NavData® Alert

Subject: Vancouver, British Columbia
Vancouver Intl (CYVR)
Vancouver Terminal Control Area (Class C) Airspace
Cycles 0907 & 0908

Incorrect Airspace Information

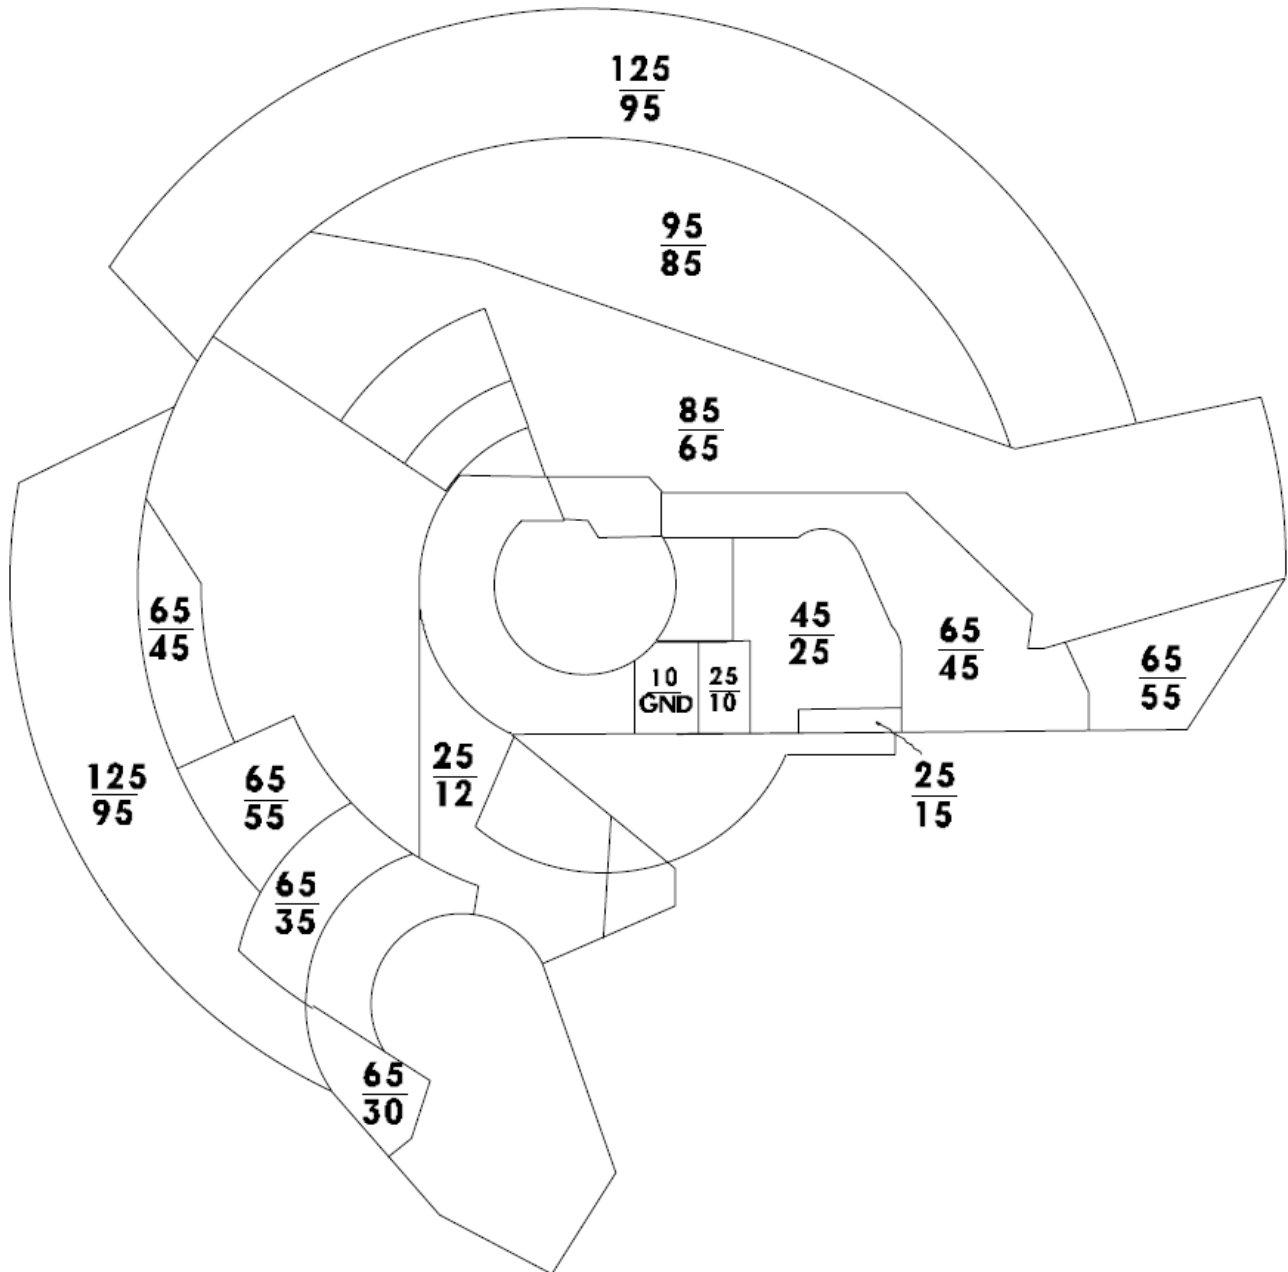
Jeppesen NavData for cycles 0907 and 0908, effective 2 July 2009 and 30 July 2009, respectively, contains incorrect lateral and vertical limits on certain sectors in the Vancouver Terminal Control Area (Class C) airspace; Vancouver, British Columbia (CYVR). The correct lateral and vertical information for Vancouver Terminal Control Area (Class C) airspace is depicted on the following page.

The following is a depiction of the corrected lateral and vertical limits for the Vancouver Terminal Control Area (Class C) airspace. The information for the airspace beneath and adjoining the Vancouver Terminal Control Area for other airports is correct and has not been depicted. Only revised altitudes that were incorrect in cycles 0907 & 0908 NavData have been shown.

Revised coding will appear in Jeppesen NavData for cycle 0909, effective 27 August 2009. Until then an entry will appear in the NavData Change Notices beginning 7 AUG 09, and this Alert will be posted on the Jeppesen Web site (<http://www.jeppesen.com/company/alerts/aviation-alerts.jsp?region=Canada%20%26%20Alaska>). Please refer to the Vancouver, British Columbia (CYVR) 10-1 chart dated 24 JUL 09 for valid information.
